Our Ref: 6121-10
Your Ref: DEV2012/399
Date: 23 January 2013

**RE: INFORMATION REQUEST RESPONSE
35A HERCULES STREET, HAMILTON
LOT 910 SP172657, PART LOT 603 SP172640, LOT 605 SP213403 & COMMON
PROPERTY ON SP172640**

ENERGY COMPLIANCE REPORT FOR DEVELOPMENT APPLICATION

**RESPONSE TO INFORMATION REQUEST FROM UDA DEVELOPMENT
APPLICATION - DEV2012/399 DATED 19 DEC 2012**

Screen Capture of Unit 21 - The lowest rating unit in the project

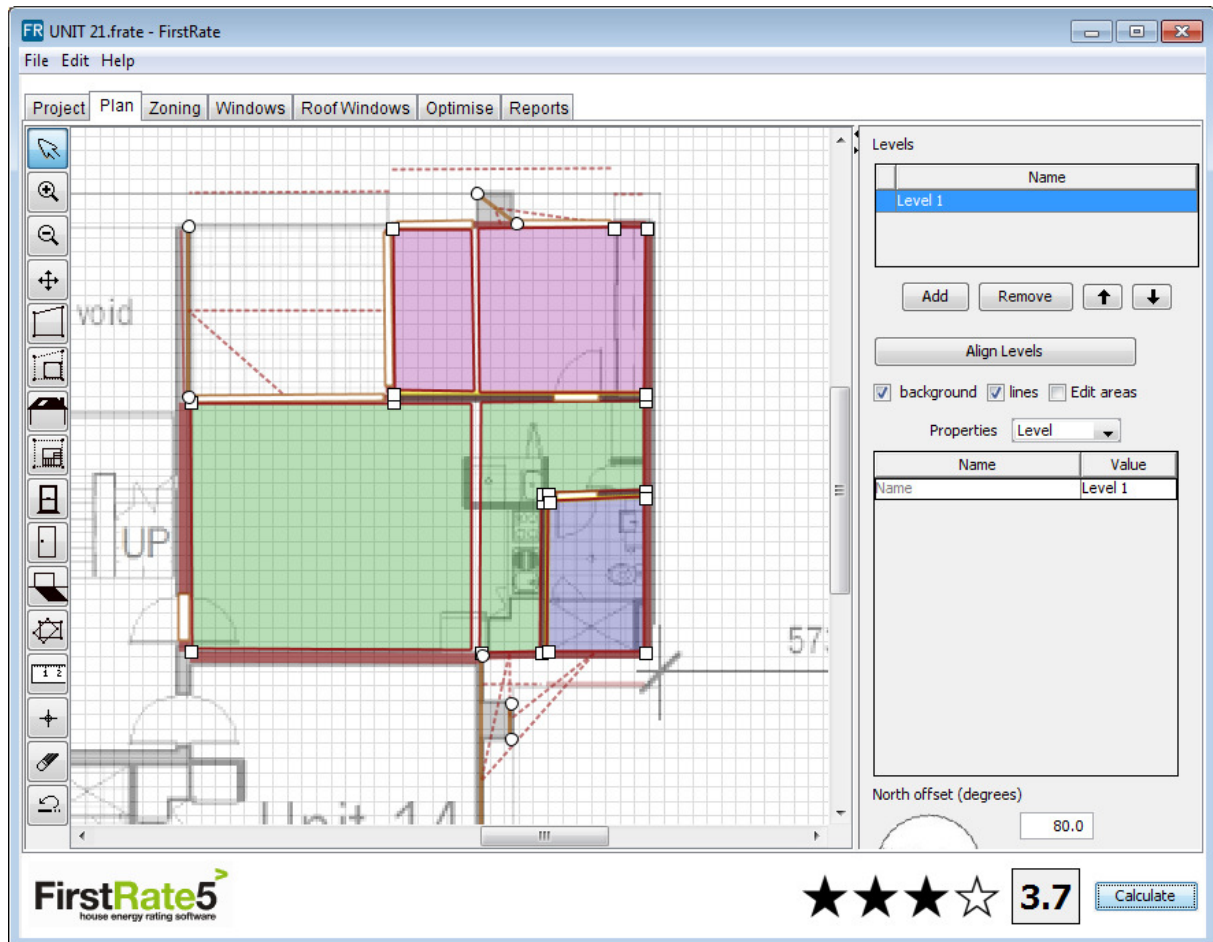
- Between Floors - Plasterboard ceiling to lightweight bondek slab with no added insulation (excluding Unit 21 detailed below).
- At Roof level – Metal roof decking with added insulation value of R3.0 minimum in the ceiling.
- Unit 21 requires added insulation value of R2.0 minimum to the ceiling below the bondek slab (plant area above) and added insulation value of R3.0 minimum in the ceiling (below the metal roof decking) where external from the Plant above.

The best performing unit and the worst performing unit (unit 10 and unit 21 respectively) were also rated using Generic 06 – Toned glass and G. James 6mm Azuria glass. The difference in performance between the 3 glazing units was negligible.
